August 16, 2011

Subject: Babcock & Wilcox Technical Services Group, Inc., NRC Project 766 (TAC NO. ME4101), Submittal of the Published B&W TSG Nuclear Topical Report No. MIPS-PP-QA-14-R3-A, Medical Isotope Production System, Quality Assurance Program Description, Revision 3

ATTACHMENT 1
B&W RESPONSE – SUMMARY OF CLARITY CONCERNS
REGARDING THE QUALITY ASSURANCE PROGRAM DESCRIPTION (QAPD)
B&W MEDICAL ISOTOPE PRODUCTION SYSTEM (MIPS)
TOPICAL REPORT MIPS-PP-QA-14
PROJECT NO. 0766
TAC NO. ME4101

Figure 1

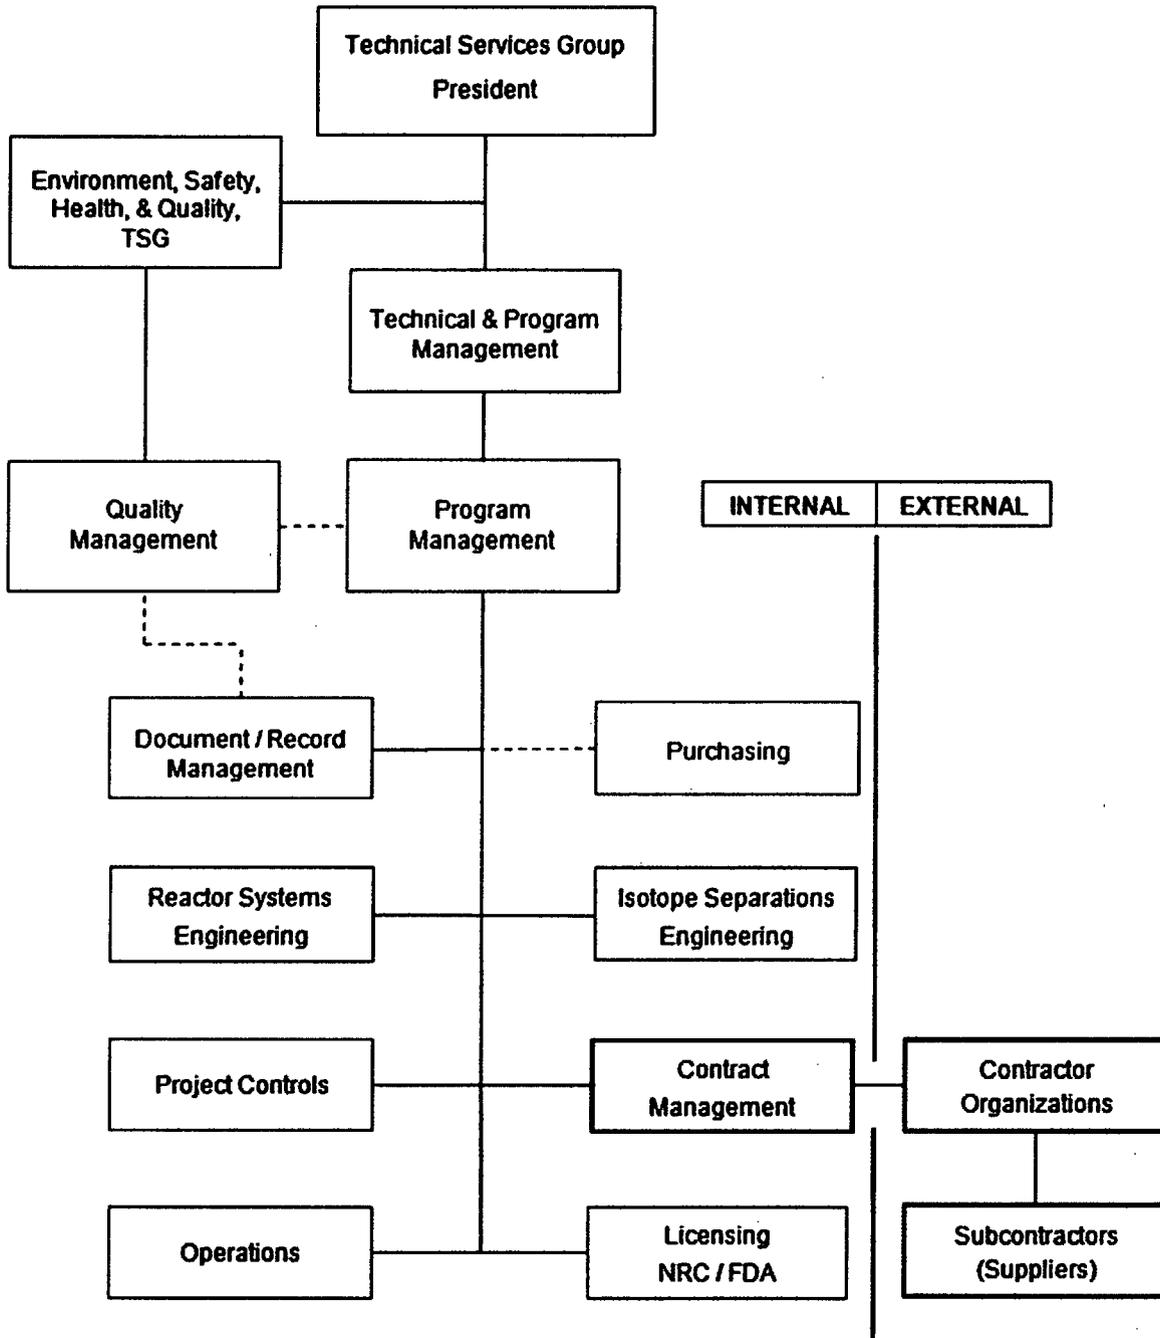
Concurrent with the clarification of the scope in the response to question 1 above, our description of the contracting approach now encompasses B&W management of multiple contractors. The organization chart Figure 1 and supporting paragraph 1.2.2.11 includes definitions of this broader generic approach to contract management.

1. Section 1.0, paragraph 1.2.2.1 "Technical and Program Management" was incorporated to describe the responsibility of the Chief Technical Officer. Figure 1 was revised to include Technical and Program Management function. This change incorporates the latest management change.
